# Service Bulletin

Bulletin No.: 20-NA-074

**Subject:** Front Fascia Paint Chipping at Headlamp Opening

5069634

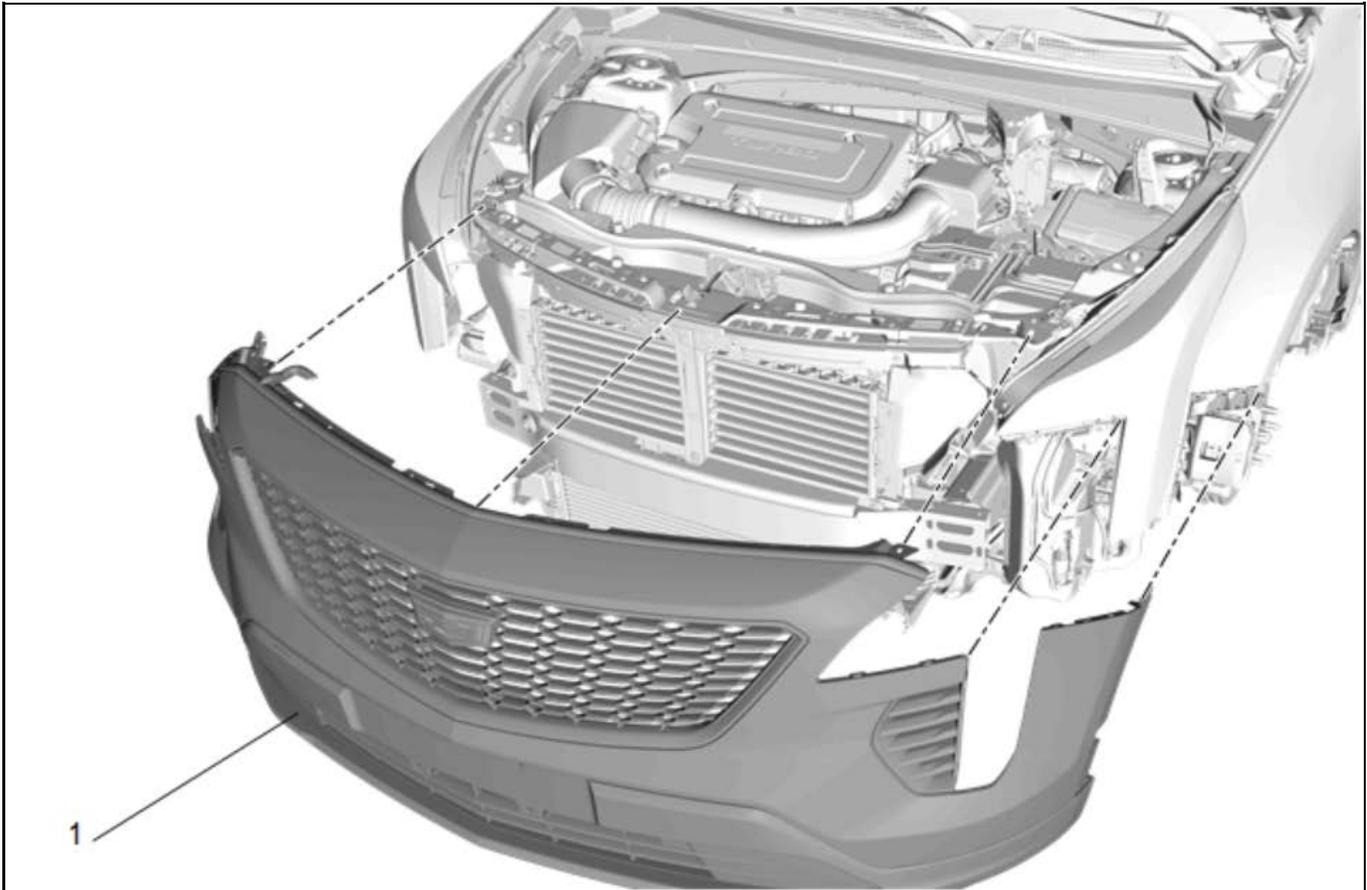
1. Remove the front fascia (1). Refer to *Front Bumper Fascia Removal and Installation* in SI.

5846562

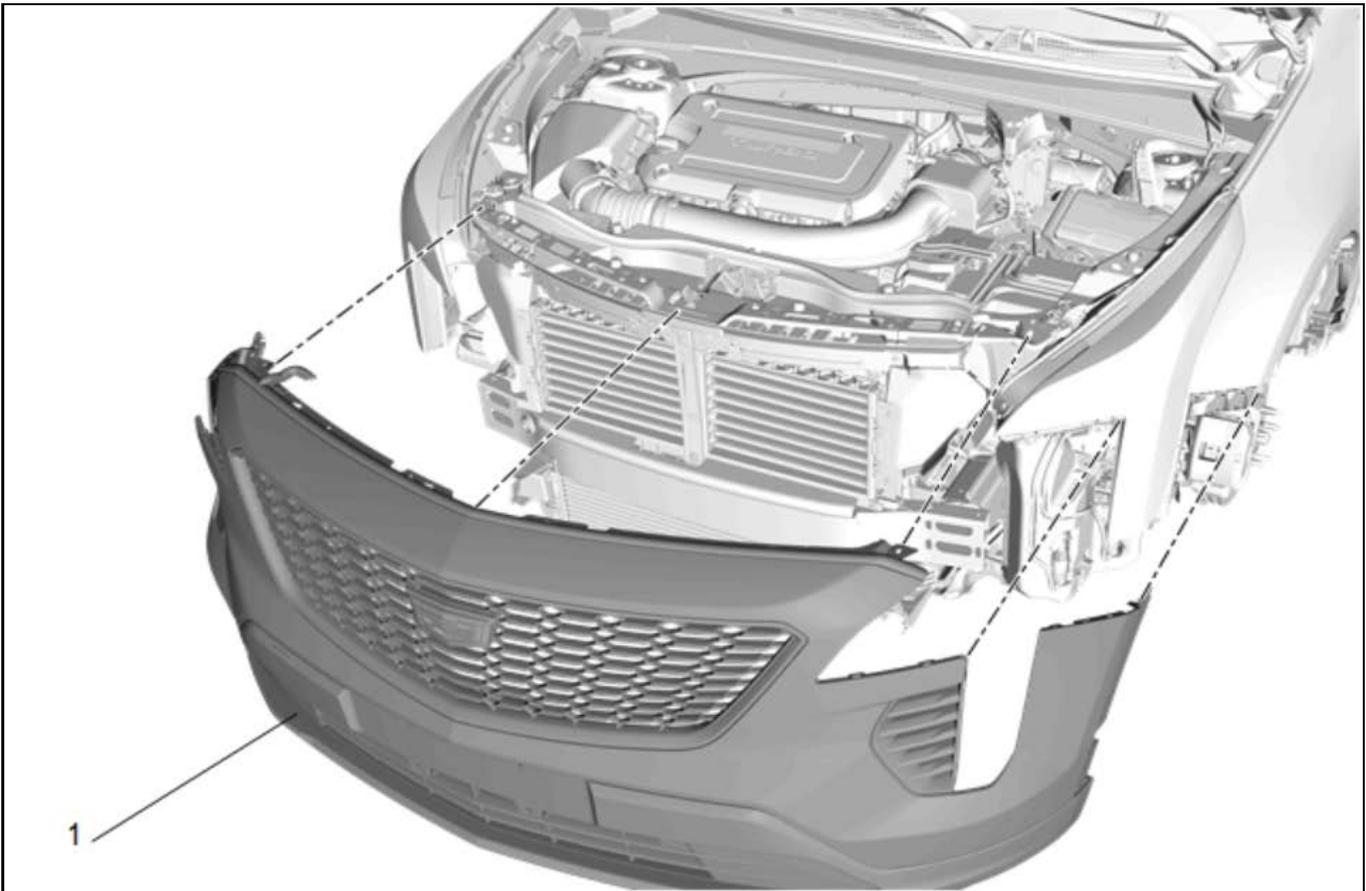
- 5.1. Start application of protective tape by removing the liner from the narrower surface side.

- 5.2. Align the top notch of the protective tape with the character line change on the lamp lens. This is where the headlamp interference with the hood starts.
  - 5.3. Align the edge of the tape along the transition point of light to dark on the lamp lens and align the bottom notch to the bottom of the lamp lens.
  - 5.4. Working from top to bottom, firmly press the protective tape to fully wet out the complete length.
  - 5.5. Again, working from top to bottom, firmly press the protective tape to fully wet out the complete length. Use of a squeegee may be helpful in pressing the protective tape into the corners.
  - 5.6. Lastly, fully wet out the top of the protective tape by pressing down into the top corner of the lamp lens.
6. Repeat step #5 on the other side headlamp.
